UNITED STATES PATENT AND TRADEMARK OFFICE

10/531,786

Office Action Summary	Application No. 10/531,786	Applicant(s) WEINSTEIN ET AL.	
	Examiner Krishnan S. Menon	Art Unit 1797

DETAILED ACTION

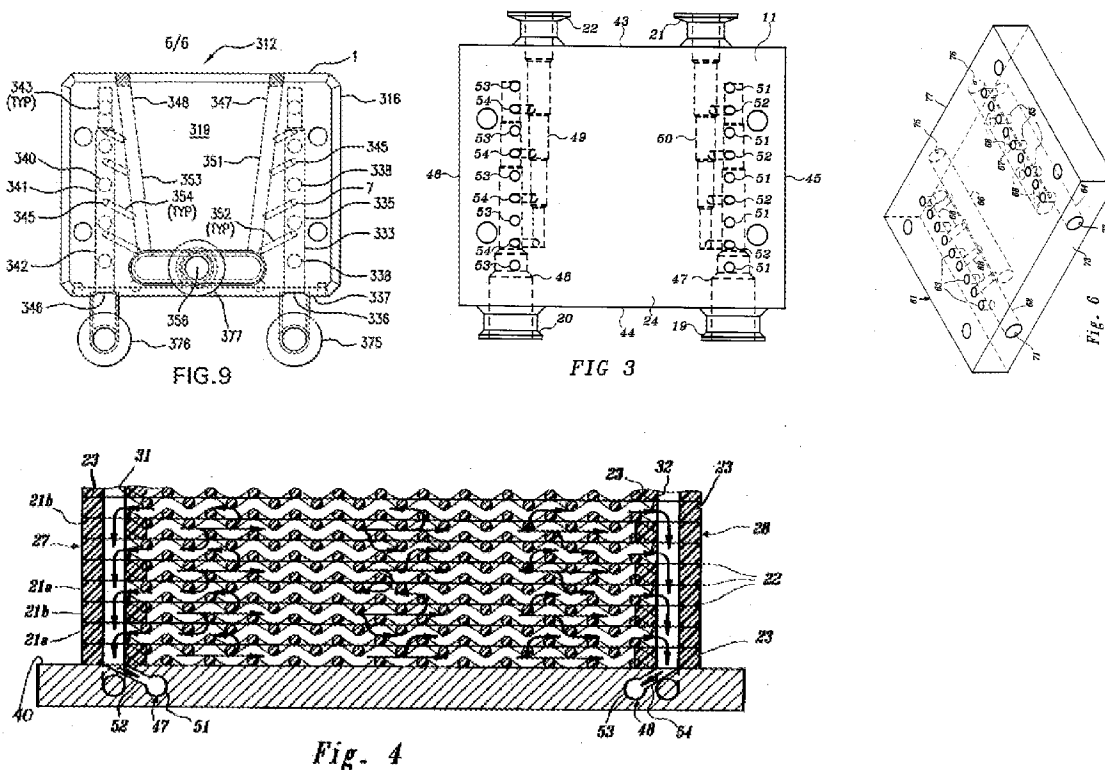
Claims 11 and 18 recite "wherein the source of fluid is configured to flow out a single outlet port". How the source of fluid could be so configured is not understood. For examination purpose, the Examiner assumes the "source of fluid" to mean the filtrate.

Also not understood is how the first and second transverse filtrate channels form acute angles that come together to provide a structural arrangement with an upper surface of the end plate. It will be helpful if applicant provides an explanation, citing the corresponding disclosure in the specification and parts in the corresponding drawings.

For examination, the transverse filtrate channels are assumed to have an acute downward angle with the horizontal plane as seen in fig 9, parts 352 and 254, marked (TYP). They join the longitudinal filtrate channels 351 and 353, which converge to port 356.

Applicant's figure 9, assumed to be best representing the claims in comparison with figure 3 of Latour and figure 6 of Friedman.

See the figure 4 reproduced above: channels (52,54) form declining acute angles so that the filtrate would drain down into the filtrate outlet channel
